# **COMMUNITY AND OTHER SUBMISSIONS**

# 8 Community and other submissions

Figure 8-1 Performance of a station at Alexandria

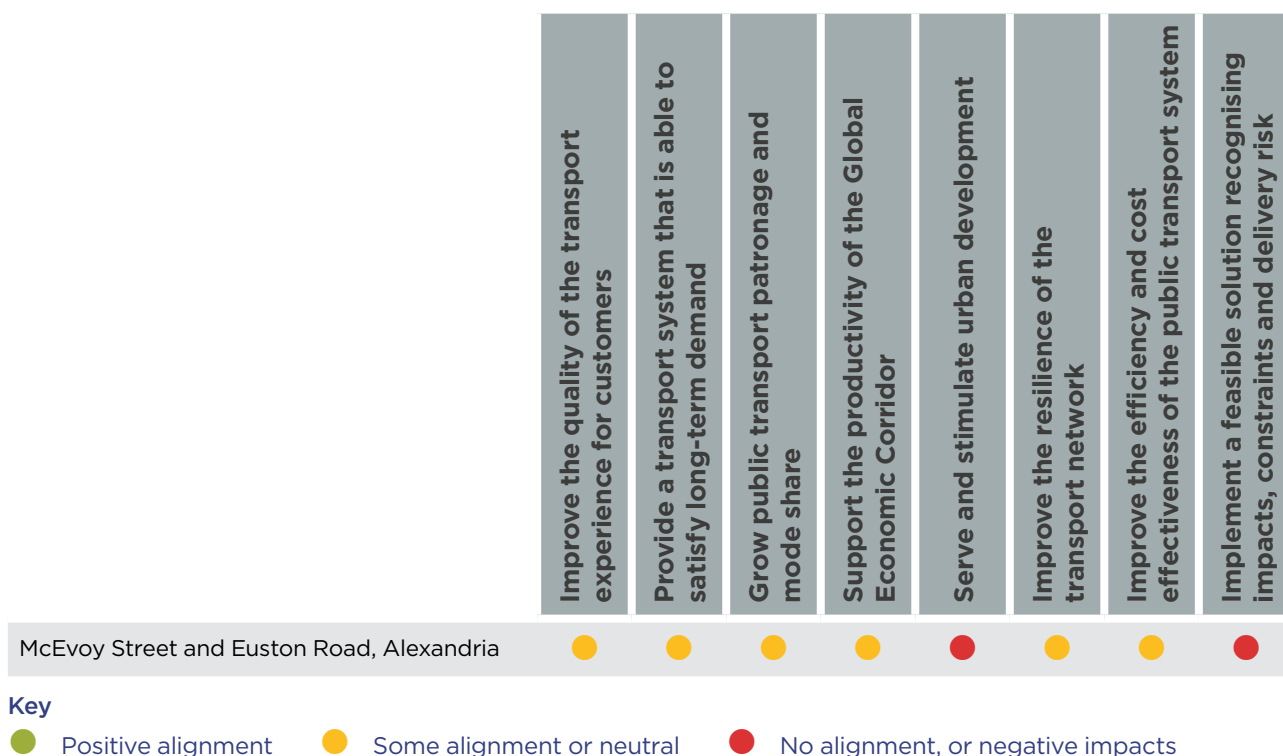
- New underground metro platforms at Green Square Station should be considered to provide connection to Sydney Airport
- Additional stations in the inner southern suburbs and between Waterloo and Sydenham (Alexandria, Erskineville, St Peters, Mascot) should be constructed for the following reasons:

In response to the submission from the City of Sydney, a further Strategic Merit Test has been conducted to investigate the opportunity for an additional metro station near the junction of McEvoy Street and Euston Road, Alexandria. A station at this location would serve a predominantly residential catchment with some mixed use developments and provide a new connection to the City of Sydney’s Southern Employment Lands. It would have some overlapping catchments with Green Square Station, Erskineville Station and the new Waterloo Metro station, so would serve a partial new rail catchment. The size of the new catchment is relatively small and contains very limited potential for employment and population growth.

As demonstrated in Figure 8-1, this station location at Alexandria performed similarly to the Strategic Merit Test results of a metro station location at Ashmore, Australian Technology Park, Erskineville, Newtown, Redfern, St Peters and Wilson Street (Eveleigh) (as referred to in Section 4.4.3 of the Environmental Impact Statement).

In response to the objective noted in the table above to ‘improve the resilience of the transport network’, analysis of Erskineville Station patronage in 2014 found that customers can experience train loading of above 135 per cent, which is the benchmark beyond which passengers start to experience crowding and dwell times can impact on-time running. However, it was one of the lower patronised stations on the Sydney Trains network (ranked 118th) with the average number of customers using Erskineville Station during the morning 3.5 hour AM peak period was 1,360 (entries and exits). A station in Alexandria may attract customers from Erskineville Station; however the number of customers would not be high.
